EXHIBIT B

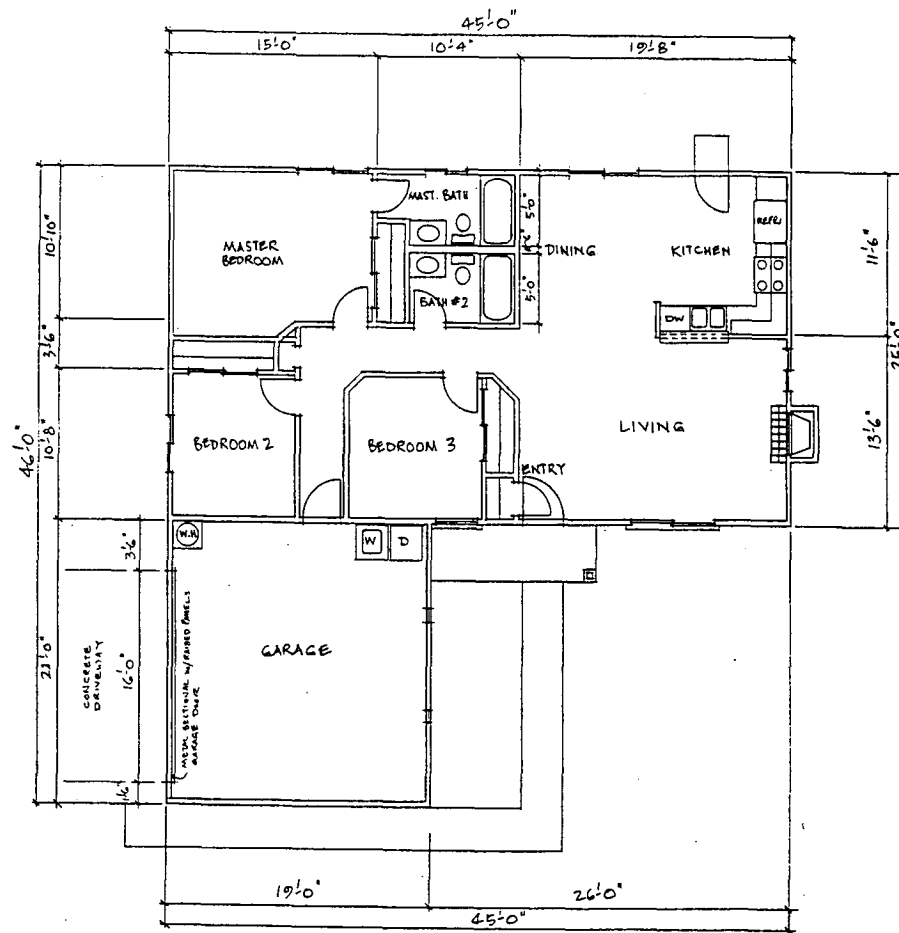
- a. revise the front unit floor plan and right elevation to match (retaining a porch element);
 - b. use horizontal lap siding on all elevations for the front unit and on the gable ends of the second and third units (see Staff Exhibit E);

- d. enlarge the front unit's garage to twenty feet in depth;
 - e. the individual driveways for all units shall be 20 feet in depth;
 - f. the second and third units shall use the floorplans as shown in Exhibit D and provide a porch element for the front door for each unit;

① FRONT (SOUTH) ELEVATION (UNIT 1 ONLY)
SCALE: 1/4" = 1'-0"

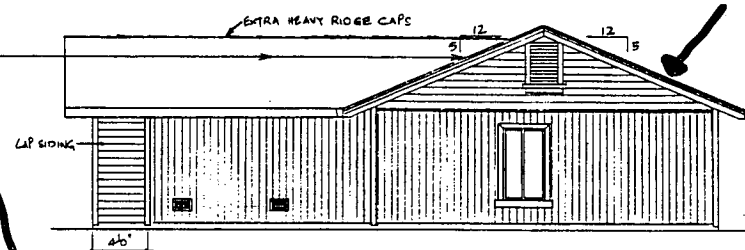
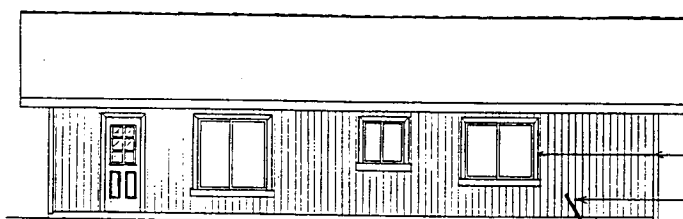
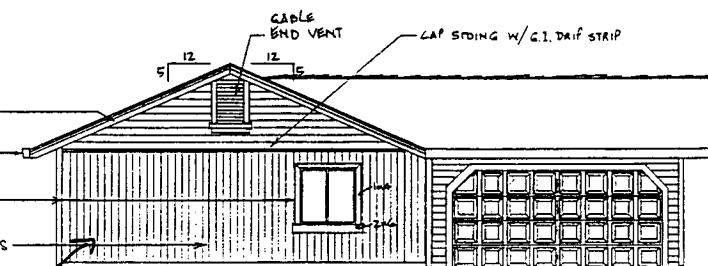
FOR UNIT 1
ALL ELEVATIONS
TO HAVE

HORIZONTAL SIDING

To be Horizontal
Siding

EXHIBIT - F

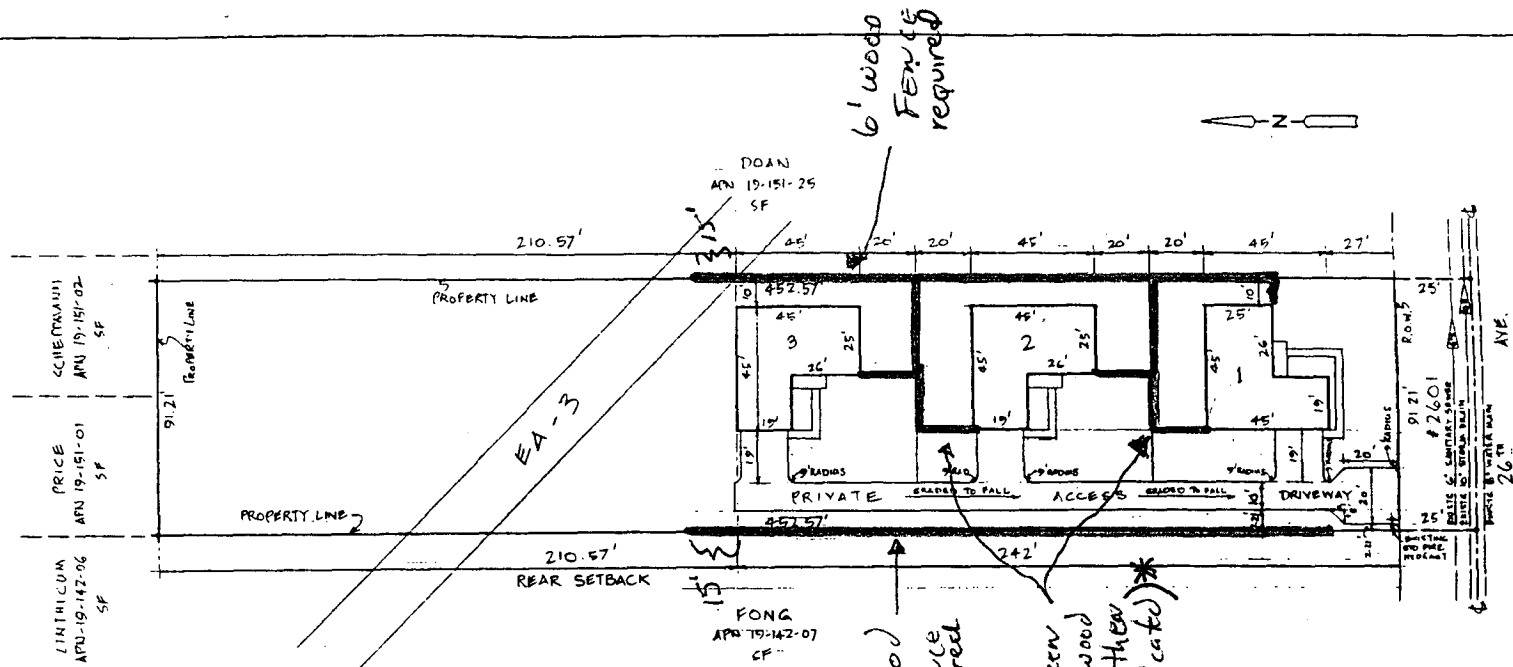
- k. a six foot wood fence shall be provided along the east and west property lines to a distance of at least fifteen feet beyond the rear of the third unit (the existing fence shall be replaced) and some type of fencing shall be provided between units; however, if a six foot wood fence is used then the fence shall not project past the front elevation of each unit (see Staff Exhibit

F){Fencing shall be installed prior to Final Inspection}. Hedges can be used in place of fences between the interior units provided the applicant provide a landscape plan for Planning review and approval prior to issuance of building permits;

PLOT PLAN
SCALE: 1" = 20'6' wood
fence
required6' wood
fence
requiredFencing between
units (if 6' wood
fencing used then
locate as indicated)*

* If applicant utilizes
3' fence, it can extend
into front yard areas of
units. The interior north/south
fencing is not required but the
east/west fencing or hedge
between units is required (condition)

EXHIBIT - G

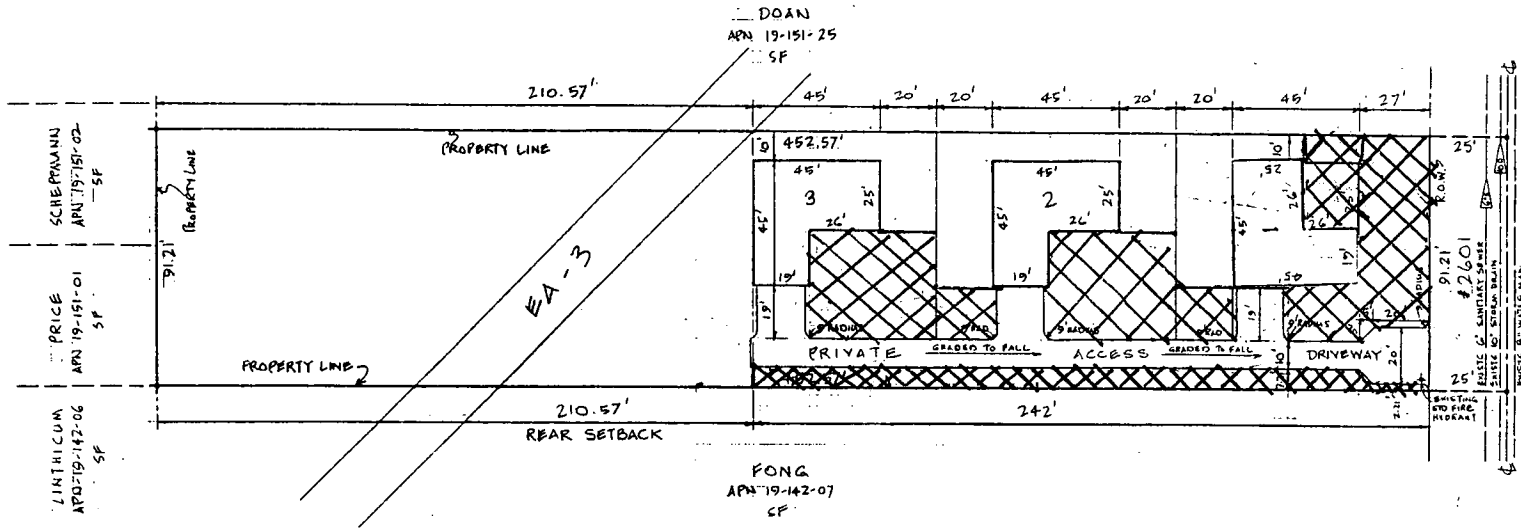
1. there shall be no parking of vehicles, dumping, or non-enclosed storage on the vacant rear section of the lot;
- m. the front area of each unit shall be landscaped with sod, shrubs, at least one tree, and irrigated with an automatic sprinkler system and there shall be landscaping to include shrubbery located along the driveway adjacent to the fence to the end of the pavement (see Staff Exhibit G).

*Hatched Areas
to be landscaped*
